**1.3 1221-1249 CENTRE ROAD, OAKLEIGH SOUTH
USE AND DEVELOPMENT OF LAND FOR PRELOADING OF EARTH AND
CONSTRUCTION OF BUILDINGS AND WORKS (DRAINAGE SWALES), THE
REMOVAL OF NATIVE VEGETATION AND ALTERATION OF ACCESS TO A ROAD IN
THE TRANSPORT ZONE 2
(TPA/53477)**

EXECUTIVE SUMMARY:

This application proposes further remediation and rehabilitation works on the site of the former Talbot Road Quarry and landfill. Ground improvement works (pre-loading) are proposed on the eastern side of the site, within Domains 2A, 2B, 3A, 3B, and 5.

Northern End Sectional diagram showing preload with a crest setback of 12.5 metres and RL of 65

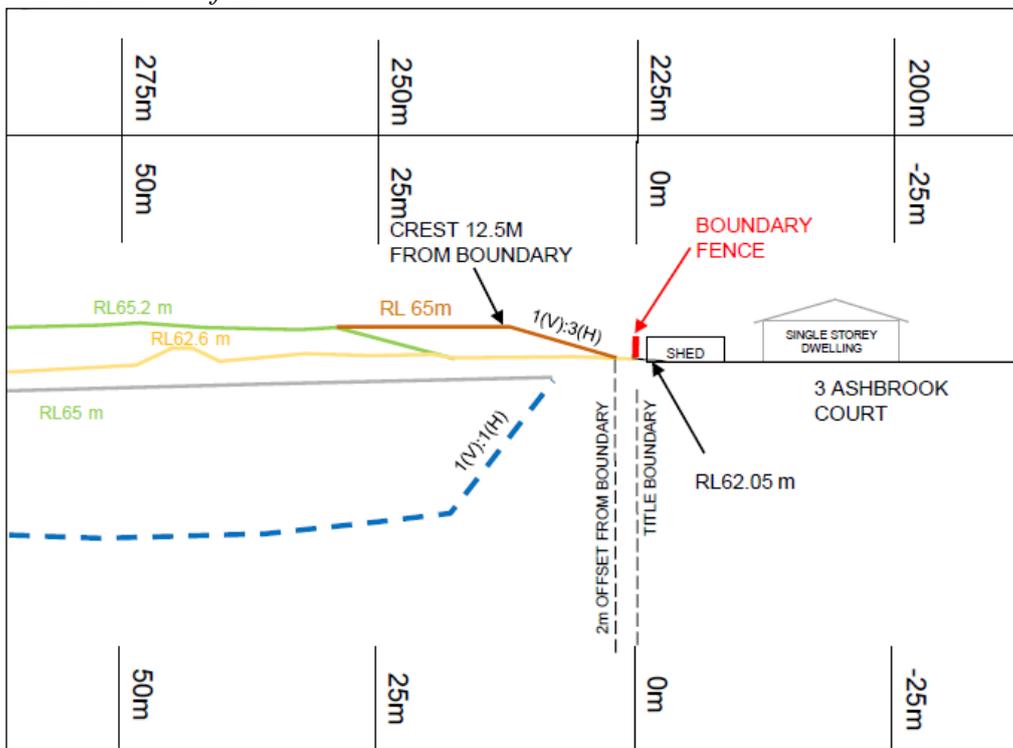
- Concern is raised with the slope of the batter in relation to the proximity of the boundaries and the interface with the residential properties (including the proximity of the preloading works to the boundaries). This will need to provide for a more gradual and gentle slope.
- Concern is also raised with respect to the proximity of the proposed swale drain to adjoining properties, and potential negative impacts that this may cause.

stormwater water from the crest of the stockpile is collected and drained away from neighbouring properties. The placement of the swale is to mitigate any potential impacts from stormwater. The swale at the crest of the batter services the catchment at the top of the preload and has been added to protect the batter face from erosion whereby flows are captured and diverted from accessing the batter face. Silt fence and sediment traps will manage the movement of any sediment. The proposed CEMP measures, together with a regime of regular inspection and maintenance to ensure the system is fit for purpose, will adequately manage stormwater.

TITLE: SITE ENVIRONMENTAL
 MANAGEMENT PLAN
 DOMAINS 2a, 3a, 3b & 5

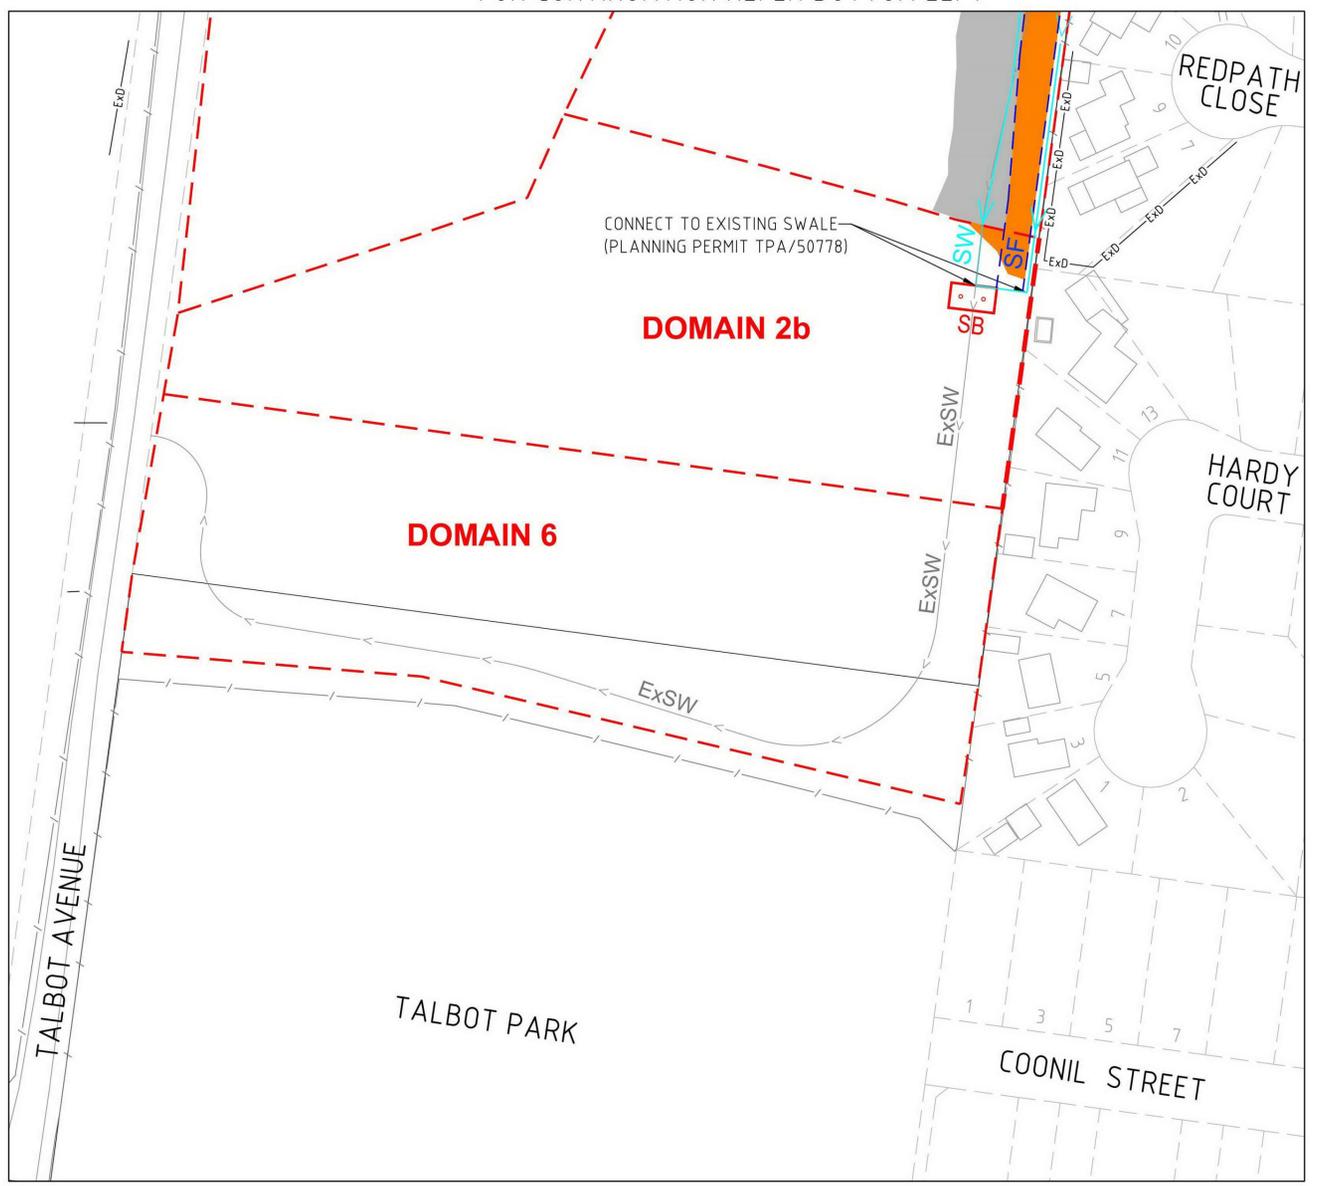
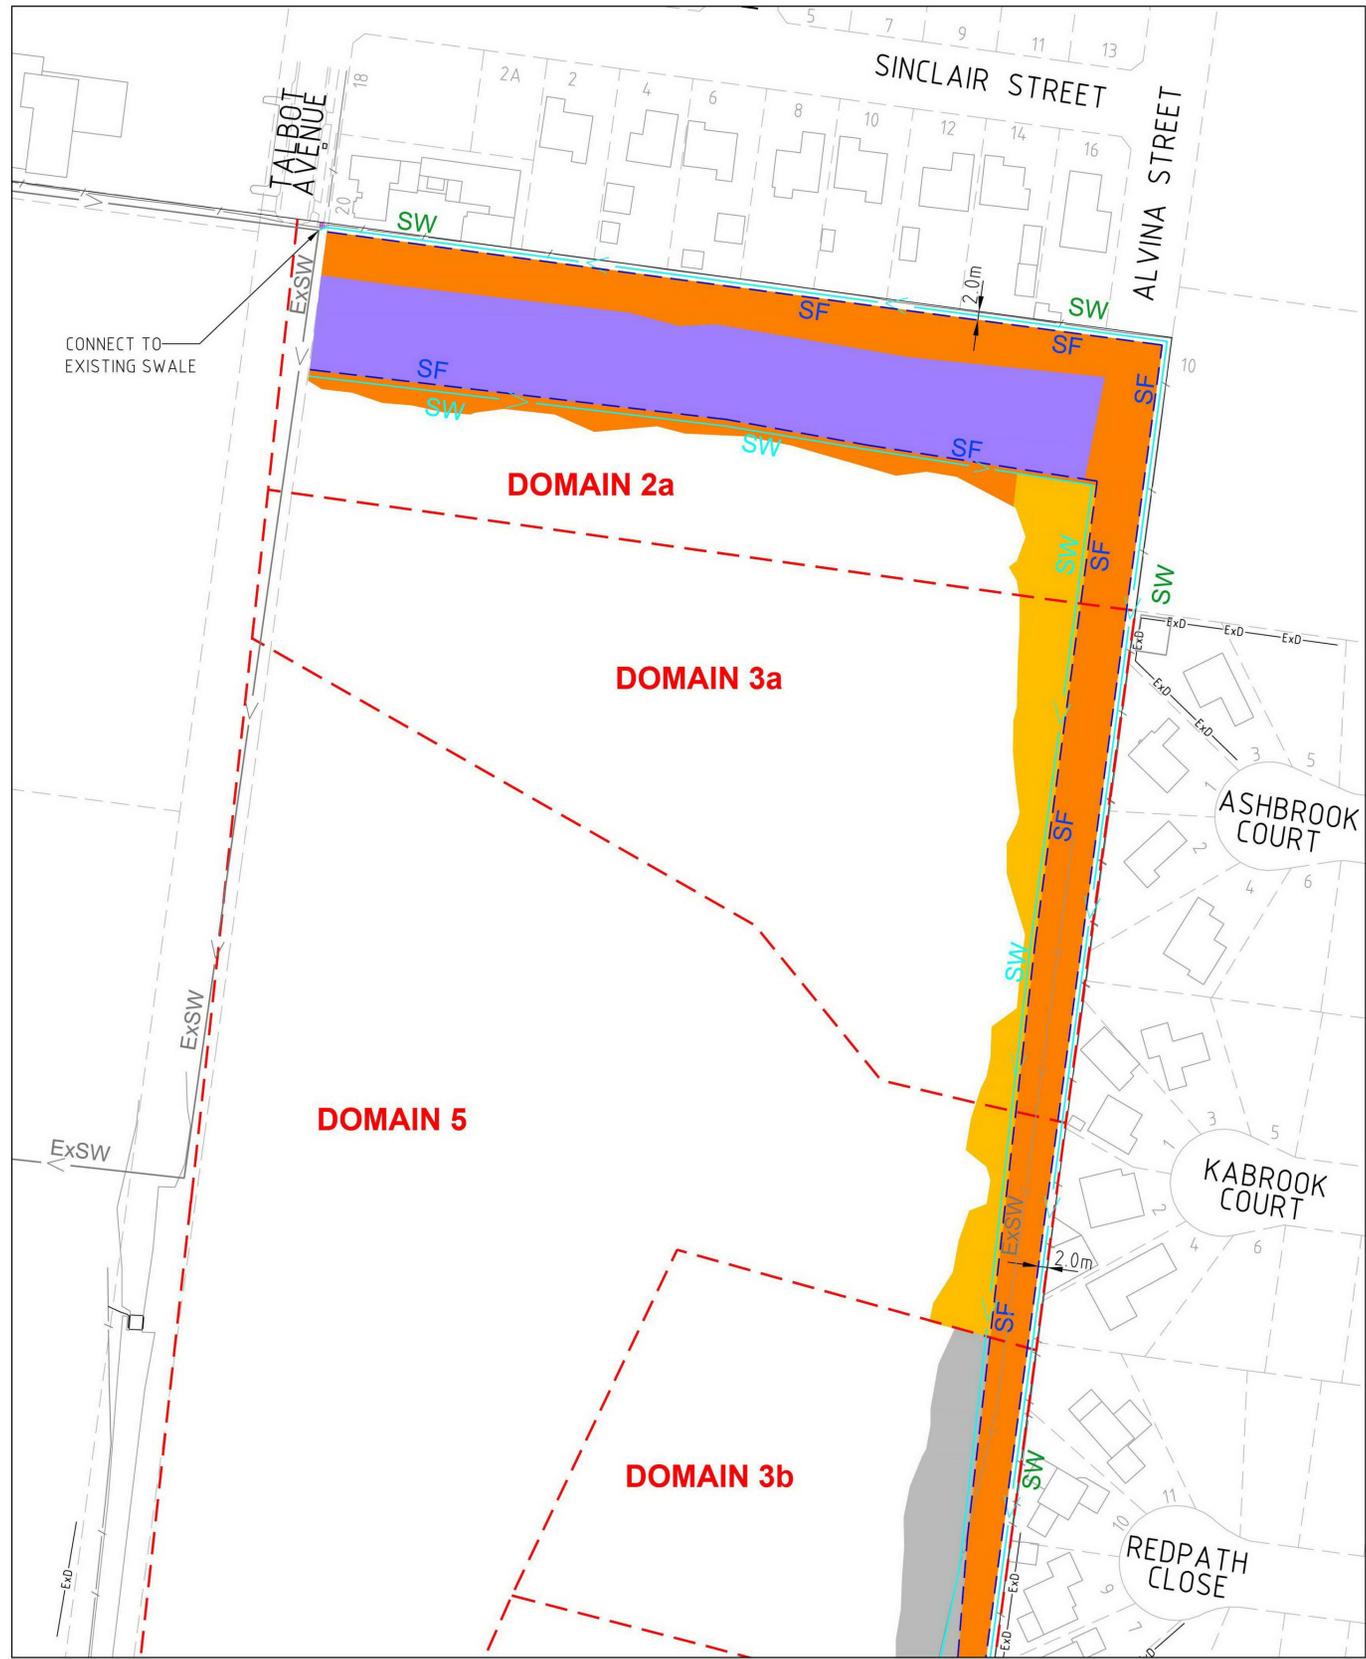
- c) The location of the crest of the sand quarry pits in relation to the property boundaries to be shown on the Site Environmental Management Plan prepared by Verve, dated 23 November 2021.
